ARMoured CAR, DAIMLER, MKS 1 AND 2

TECHNICAL HANDBOOK - MODIFICATION INSTRUCTION

1. This instruction concerns the fitting of an oversize bush to the fluid flywheel, rear casing, when necessary.

Fig 1 - Rear casing oversize bush

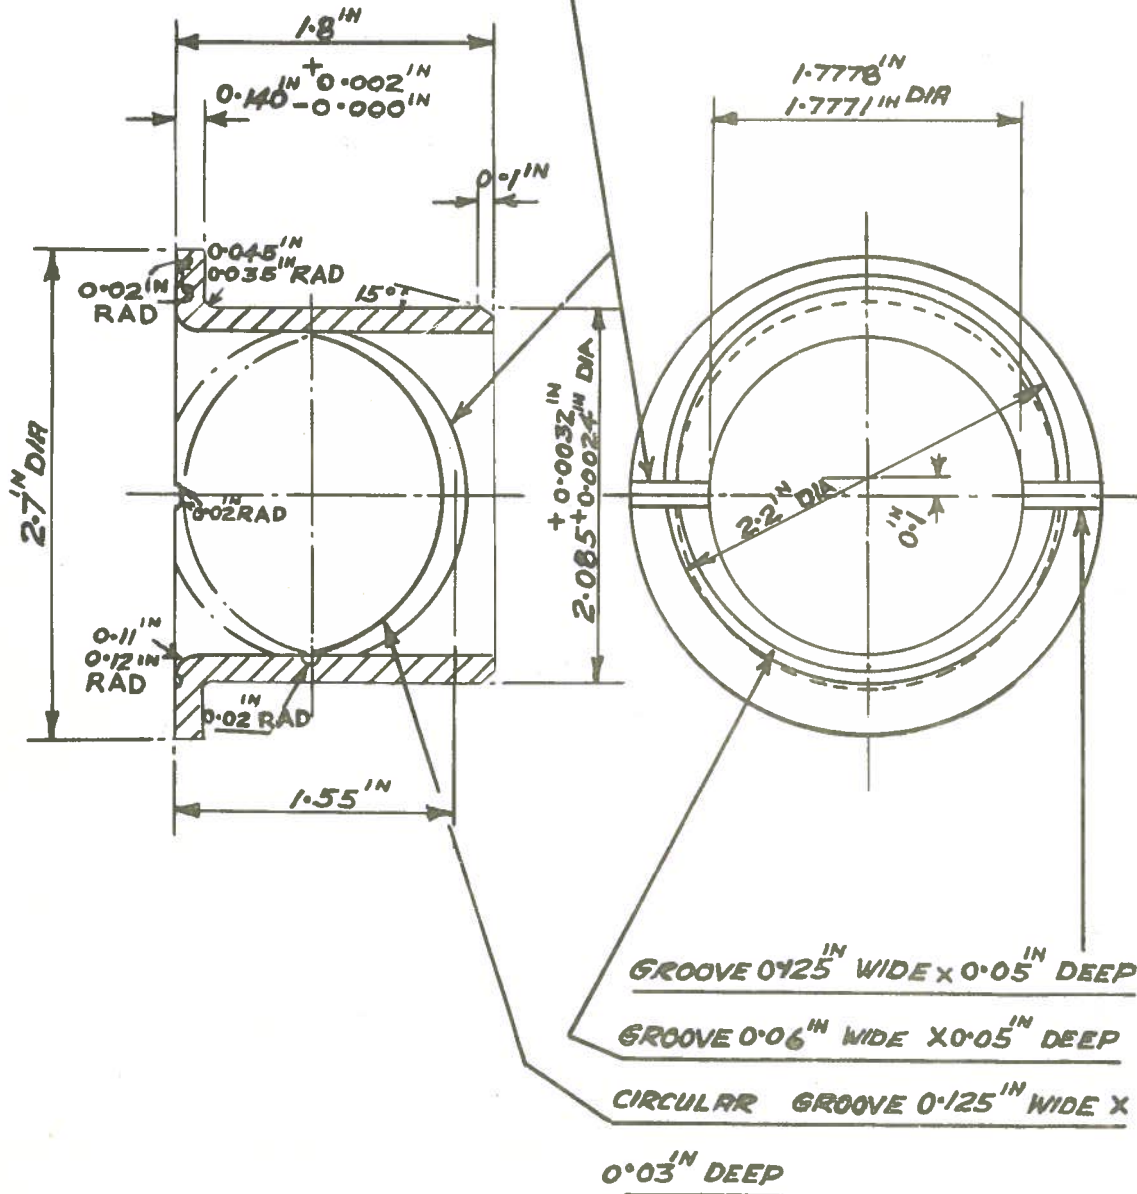
6. When the existing bush is found to be turning in the casing, it will be replaced by a bush manufactured locally.

- (a) Remove existing bush.
(b) Machine bearing housing to within the dimensions of $2.085^{+0.0006}_{-0.0004}$ inches.
(c) Manufacture oversize bush as detailed in Fig 1.
(d) Fit oversize bush to casing.

THIS GROOVE MUST BREAK INTO
THE FACE GROOVE AS SHOWN

MATERIAL:- PHOSPHOR BRONZE
